**CITY OF TEMPE
DEVELOPMENT REVIEW COMMISSION**

Meeting Date: 12/08/2015
Agenda Item: 7

ACTION: Request for a Development Plan Review consisting of a new eighteen-unit apartment community on one acre and a Use Permit for tandem parking for **HOWE AVENUE APARTMENTS**, located at 2185 E Howe Avenue. The applicant is Bryan Celius of Studio Y Design & Development LLC.

BACKGROUND INFORMATION: **HOWE AVE APARTMENTS (PL150427)** is a proposed on a .989 acre lot that is zoned R-3 Multi-Family. The proposed development is for an eighteen-unit two-story apartment community consisting of four buildings designed as four-plexes and one du-plex building, which is located in the Transportation Overlay District (TOD) Corridor at the south west corner of Howe Avenue and Price Road. The request includes the following:

Sheet Number: **A1.1**

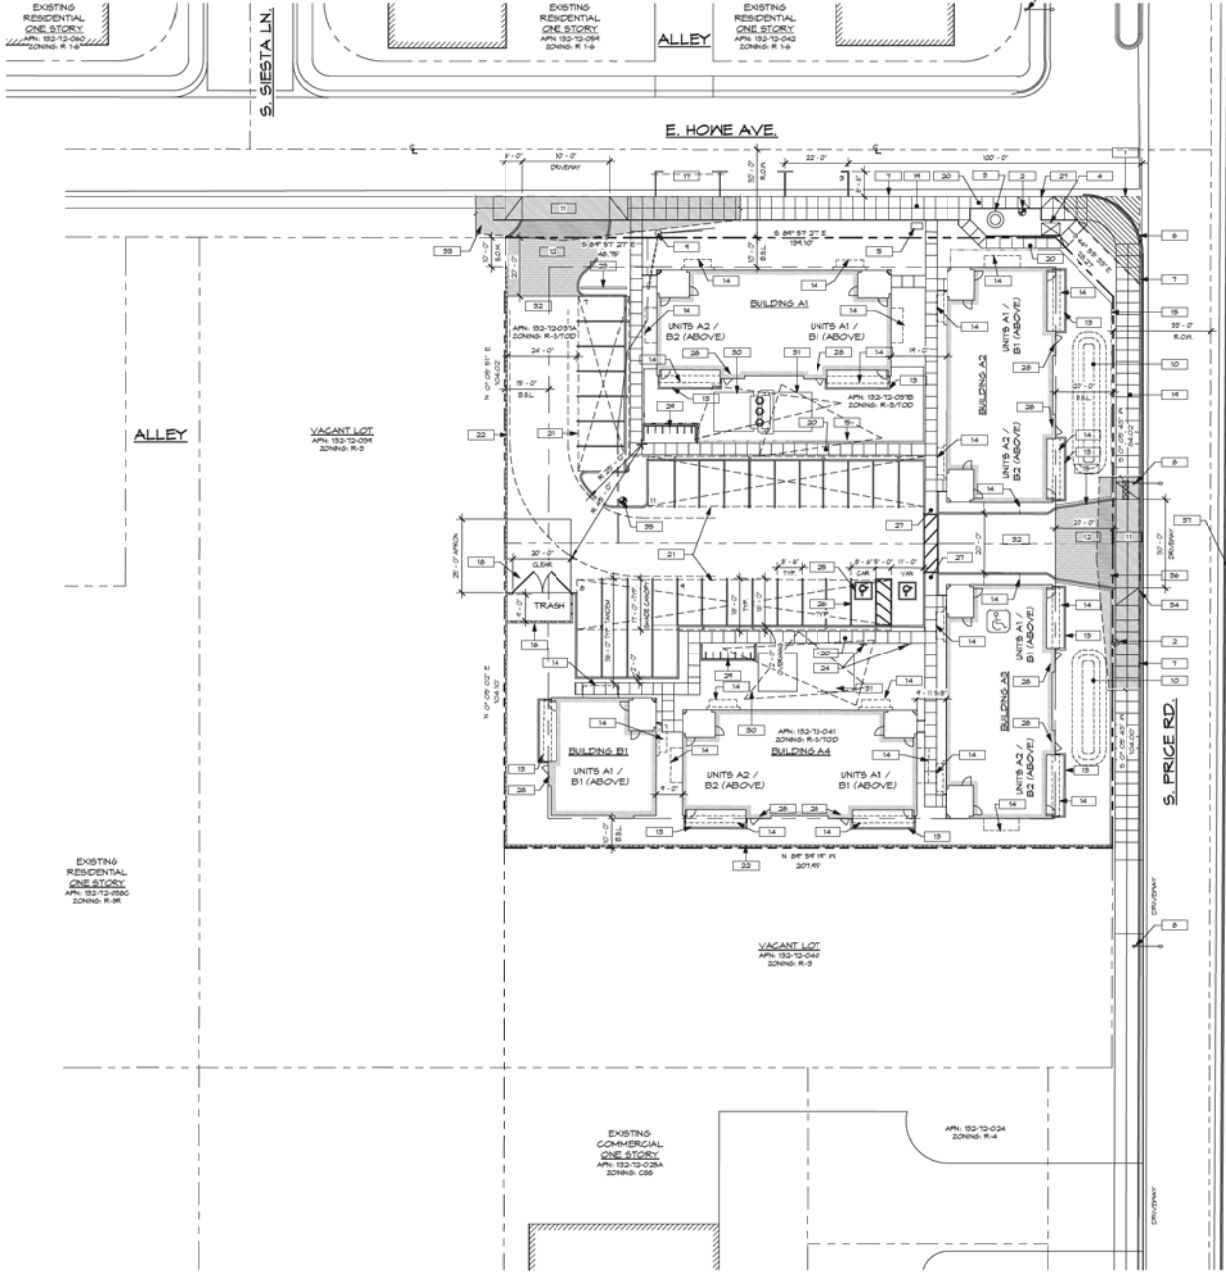
6. The site plan is approved as submitted (November 9th, 2015), minor modifications may be reviewed through the plan check process of construction documents; major modifications will require submittal of a Development Plan Review.
7. Verify height of equipment and mounting base of mechanical equipment to ensure that wall height is adequate to fully screen the equipment.
8. Provide gates of steel vertical picket, steel mesh, steel panel or similar construction. Where a gate has a screen function and is completely opaque, provide vision portals for visual surveillance. Provide gates of height that match that of the adjacent enclosure walls. Review gate hardware with Building Safety and Fire staff and design gate to resolve lock and

9. Provide upgraded paving at each driveway consisting of unit paving. Extend this paving in the driveway from the right-of-way line to 20'-0" on site and from curb to curb at the drive edges. From sidewalk to right-of-way line, extend concrete paving to match sidewalk.

12. Shade canopies for parking areas:
 - a. Provide an 8" fascia for the canopy structure.
 - b. Maximum 75% light reflectance value shall also apply to the top of the canopy.

A9.1

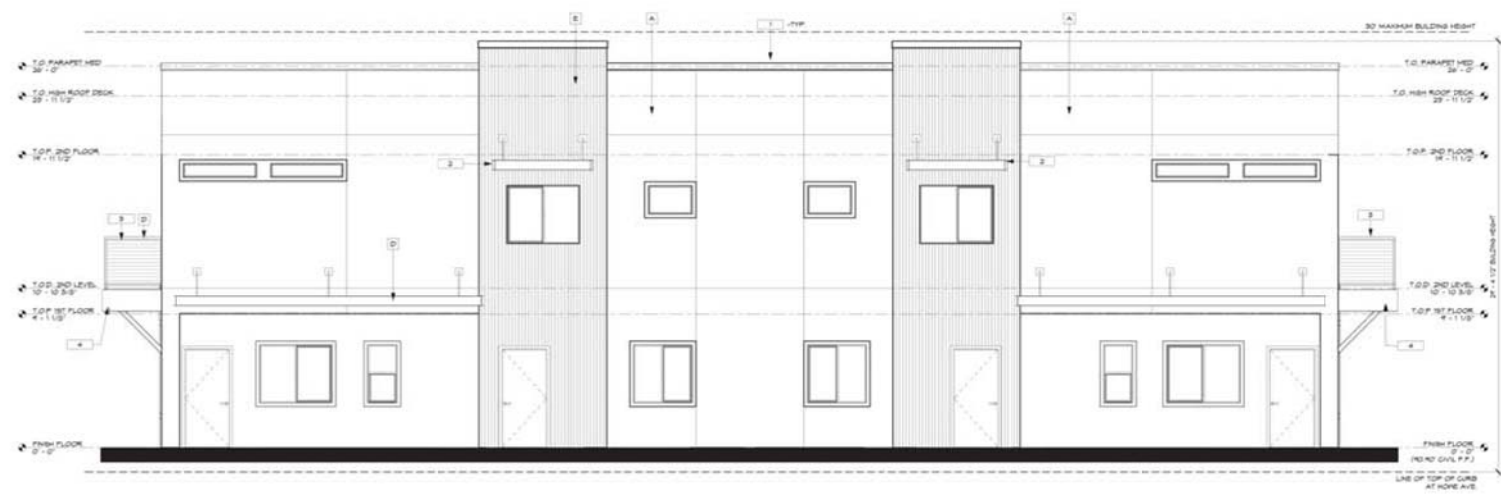
13. The materials and colors are approved as presented (Based on the elevation plans A9.1, A9.2, A9.3 received on November 9th, 2015):
 - Primary building – Painted Stucco – DE6158 Buckskin
 - Secondary Building (Pop Out) – Metal T-Panel Veneer – Berridge Medium Bronze
 - Building Accent – 8"x8"x16" CMU Mesastone – Pearl
 - Building Field - 8"x8"x16" CMU Mesastone – Mojave Brown
 - Parapet Cap – Painted Metal Elements – Burgundy
 - Roof Canopy - Painted Metal Elements – Burgundy
 - Guardrail @ 46" A.F.F – Painted Metal Elements – Burgundy
 - Trim over Edge Balcony - Painted Metal Elements – Burgundy
 - Balcony Bracket - Painted Metal Elements – Burgundy

14. Provide Mesastone CMU to all four sides of each building type at the wainscot level.
15. Provide secure roof access from the interior of the building. Do not expose roof access to public view.
16. Security window side lights adjacent to doors must remain in the final design or doors shall be designed with vision panels for resident safety.
17. Conceal roof drainage system within the interior of the building; gutters are not to be located on the exterior face of the structures.
18. Incorporate lighting, address signs, and incidental equipment attachments (alarm klaxons, security cameras, etc.) where exposed into the design of the building elevations. Exposed conduit, piping, or related materials is not permitted.
19. Locate the electrical service entrance section (S.E.S.) inside the building or inside a secure yard that is concealed from public view.
